41, Eastern Avenue
Reading
RG1 5RX

Structural feasibility report

Clive Hudson Associates
Consulting Structural & Civil Engineers

Jan 2026
Project Ref: 256939

Figure 8. Proposed basement plan – extracted from Colony Architects drawing 03-11.

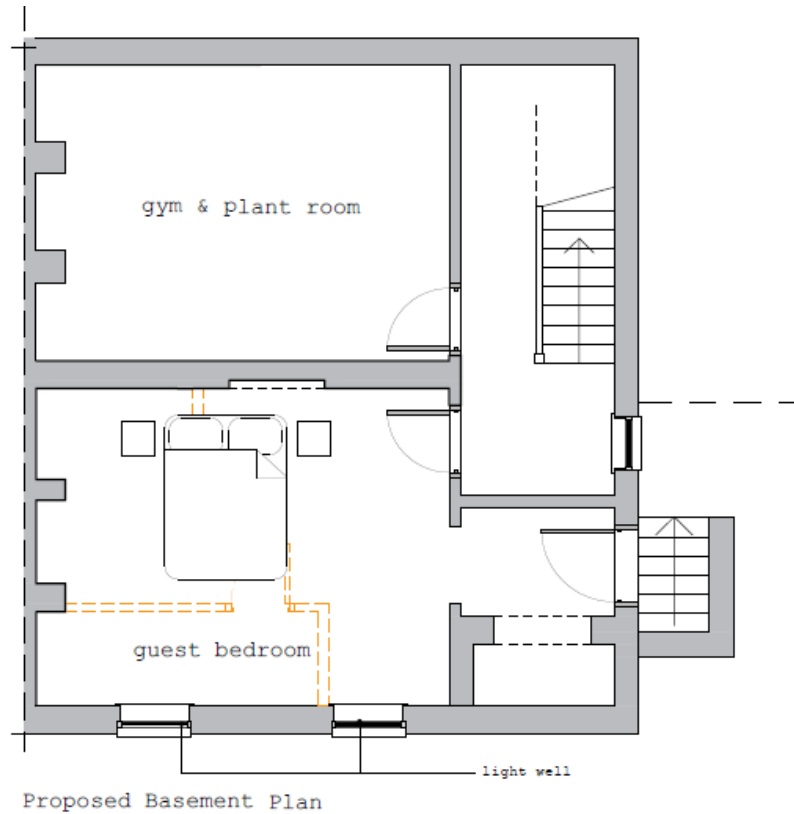
- i. The architectural drawings for the basement indicate that the proposed alterations comprise the removal of internal partitions from within the front room, and the insertion of two lightwells in the front wall (Fig. 8).
- ii. From the inspection, the partitions are clearly not historic. The east/west partition is of stud construction, while the partition towards the front elevation is of blockwork construction.
- iii. The ground floor construction comprises timber joists that span north-south, with internal support provided by two downstand timber beams that span east-south. Both beams are supported by the north/south blockwork partition (Fig. 9).

The beams are circa 185mm deep x 100mm wide and span c. 3.9m. During the inspection, it was not possible to confirm whether the joists are notched over the beam or not, i.e., the beams are deeper than the 185mm measured beneath the ceiling.

Based on an initial assessment for a 185mm deep x 100mm wide timber beam spanning c 3.9m, with assumed properties equivalent to a C24 grade, the beams would fail when assessed against modern codes of practice for bending stress and deflection, without the internal support. While we recognise that modern codes of practice should not be applied unthinkingly, in the context of building conservation, we would recommend that localised opening-up works be undertaken to confirm the exact size of the beam as part of the next phase of the project, and a provisional sum is allowed to strengthen the beams.

- iv. The formation of the two lightwells does not raise any significant structural concerns at present. However, the architectural drawings currently lack detail regarding their size and position. From a structural perspective, new lintels will be required over the openings, and new retaining structures will need to be added externally to form the well(s). At this stage, we would allow to use reinforced hollow blocks with a lightly reinforced concrete slab at its base. However, clarification should be sought with the arboricultural consultant, SJ Stephens Associates, as to

whether this, or any other construction, is feasible, considering the lightwells will lie within a Ground Protection Area.

- v. Although not shown on the architectural drawings, we understand from on-site discussions with Mr Akbar, and also referenced in the Pre-application Heritage Statement, prepared by Archway Heritage, dated November 2024, that the proposals may also include the lowering of the basement floor. We would recommend that intrusive investigations be undertaken to confirm the depth and nature of the existing footings as part of the next phase, as it may be necessary to underpin the existing footings to accommodate the revised floor level and build-up. This should be investigated and finalised before the application is submitted.

Figure 12. Proposed ground-floor plan – extracted from Colony Architects drawing 03-10.

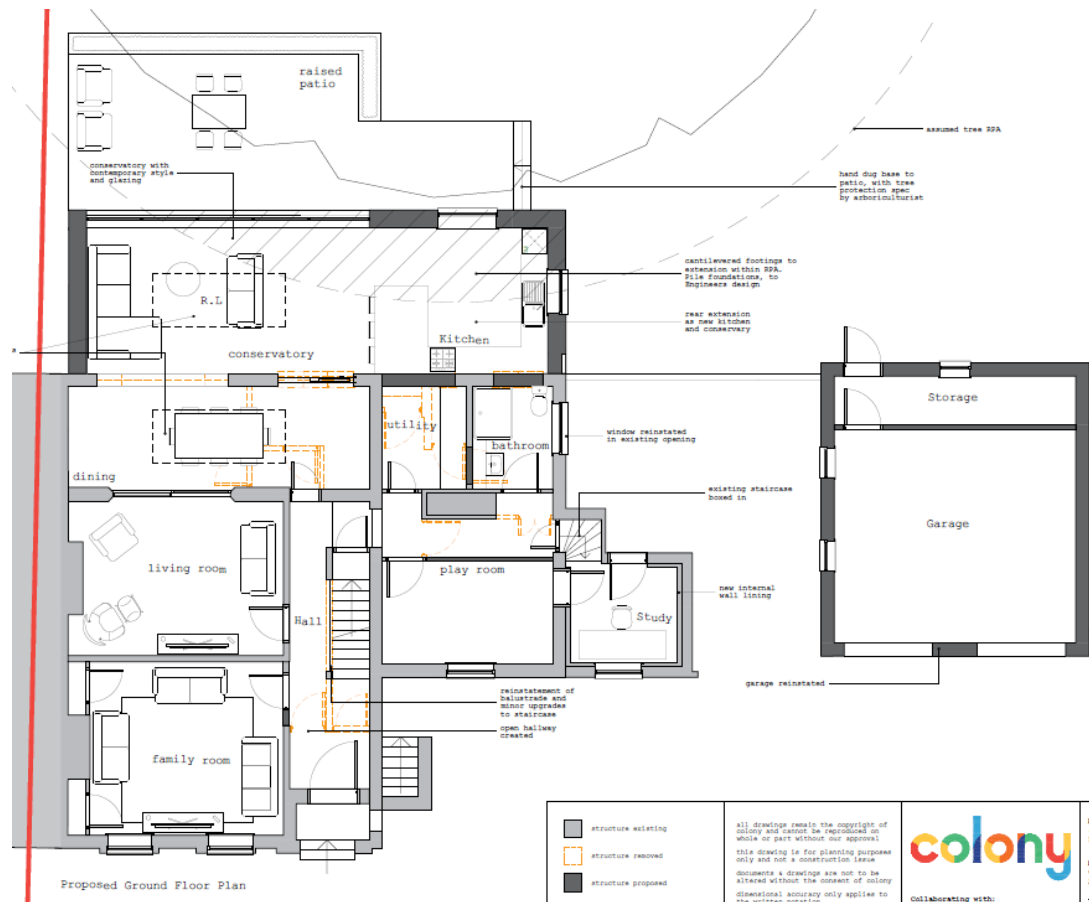
i. The architectural drawings for the ground floor (Fig. 12) indicate that the proposed alterations include:

- a new rear extension,
- the removal of the masonry wall that separates the principal staircase from the hall on the ground floor,
- the removal of non-load-bearing walls from the proposed dining room,
- the lowering of the existing openings on the rear wall of the existing rear extension,
- the removal of non-load-bearing walls from the proposed utility room,
- the infilling of existing windows and door openings in the proposed utility room and bathroom,
- the reinstatement of the window on the south wall of the proposed bathroom,
- the creation of an opening between the proposed bathroom and corridor,

- the installation of a new partition to subdivide the existing bedroom into a playroom, with a separate corridor to the proposed bathroom,
 - the creation of a new opening between the proposed playroom and study,
 - the insertion of a new rooflight in the existing flat roof, and the
 - the creation of a new window in the east wall of the proposed study.
- ii. As the new rear extension lies within the No-Dig Construction zone, we would recommend that the new foundations for the extension be piled, either incorporating an integrated reinforced concrete ground-floor slab or utilising a reinforced concrete ground-beam arrangement with a separate or an integrated floor structure. This will require a suitable geotechnical investigation to be carried out (by others) to advise on the appropriate pile design/parameters.

To minimise the risk of differential movement between structural elements founded on different substrates/foundations, we would recommend that additional internal support be introduced within the new extension to carry the new first-floor wall, rather than relying on the existing wall for support.

Figure 15. Outline of the infilled opening on the side/south elevation.

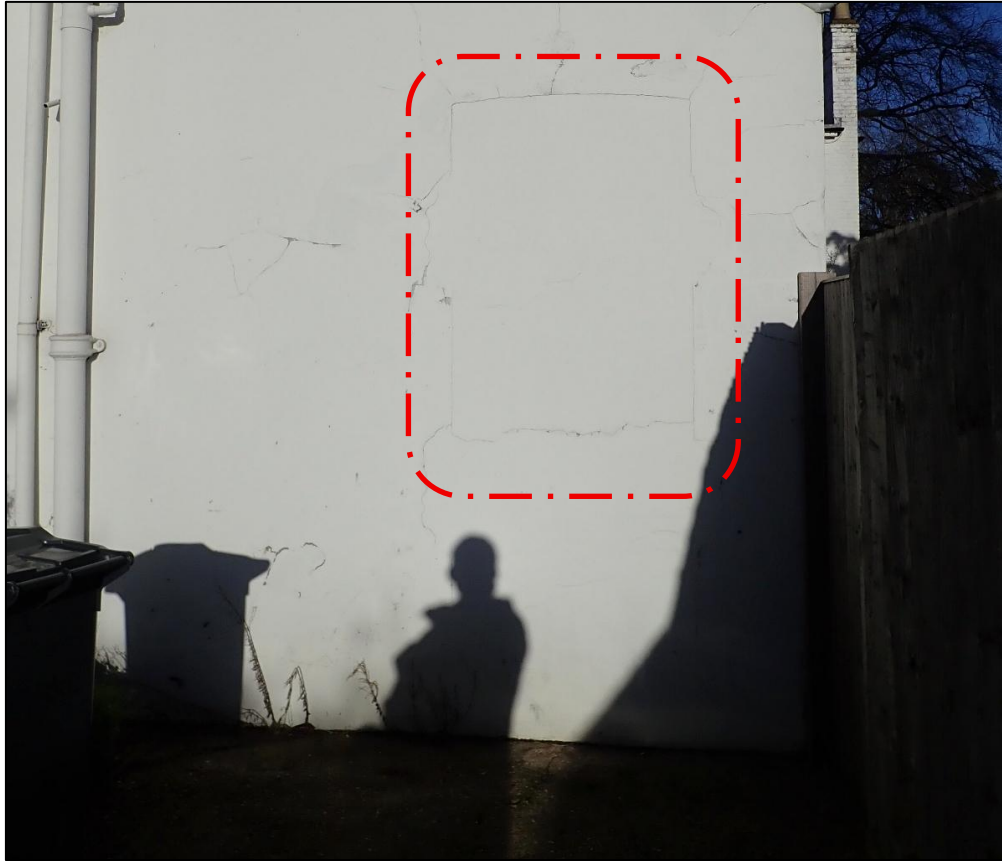
- v. As previously noted, the store has a brick paver floor, which is likely to be historic. To enable the conversion of this space to habitable usage, it is assumed that the floor will require upgrading, including the introduction of additional insulation. This should be developed by the architects before the submission of the listed building consent application.
- vi. On a similar basis, we would recommend that the floor and ceiling levels in the proposed study and playroom be confirmed before the submission of the listed building consent application.
- vii. Although it does not warrant immediate structural concern, we would allow to strengthen the brickwork over the existing opening in the proposed ground-floor bathroom (Fig. 15) using stainless steel, threaded bars and resin grout, such as Helifix Helibars and Helibond grout, should the opening be reinstated.

Figure 18. Proposed first-floor plan – extracted from Colony Architects drawing 03-10.

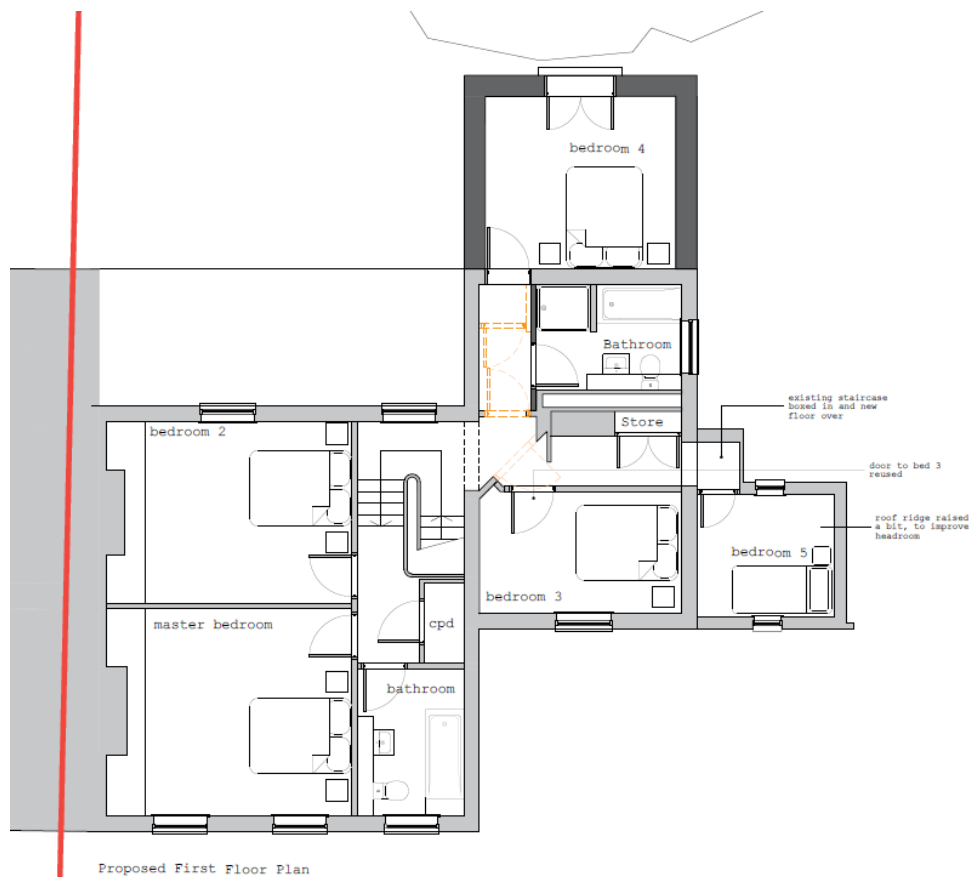
- i. The architectural drawings for the first floor (Fig. 18) indicate that the proposed alterations include:
 - The addition of a 4th bedroom to the east of the existing bathroom,
 - The introduction of new stud partitions and the removal of existing stud partitions,
 - The raising of the ridge over the proposed bedroom 5, and
 - The formation of a new opening in the existing rear wall to allow access to the new bedroom.

None of these raises structural concerns. The creation of new openings will naturally require new lintels to be introduced. We would recommend that the floor and ceiling levels in the proposed corridor and bedroom 5 be confirmed before the submission of the listed building consent application.

Figure 19. Proposed garage floor plan – extracted from Colony Architects drawing 03-10.

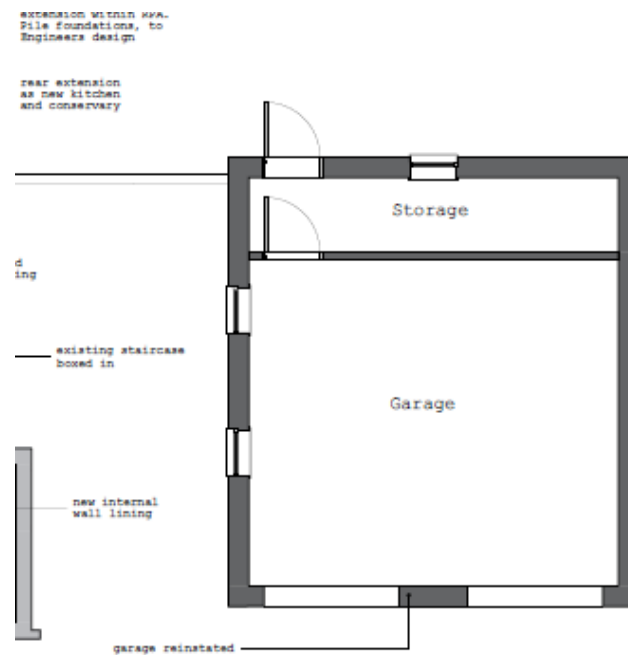
- i. The architectural proposals include a new garage adjacent to the southern boundary. The new garage will be single-storey with a duo-pitched roof. As the new garage lies within a No-Dig Construction zone, we would recommend utilising piled foundations with an integrated reinforced concrete ground-floor slab to support the superstructure, as recommended by SJ Stephens Associates. This will require a suitable geotechnical investigation to be carried out (by others) to advise on the appropriate pile design/parameters.

- ii. Although it is not a structural issue, per se, we would recommend that the widths of the openings be confirmed before the listed building consent application is submitted, as they appear to be relatively narrow, in our opinion.

- iii. While it is not a structural issue per se, the construction of the new garage is likely to fall under the 1996 Party Wall Act. As a result, we would recommend that advice be sought from a competent Party Wall Surveyor at an early stage.
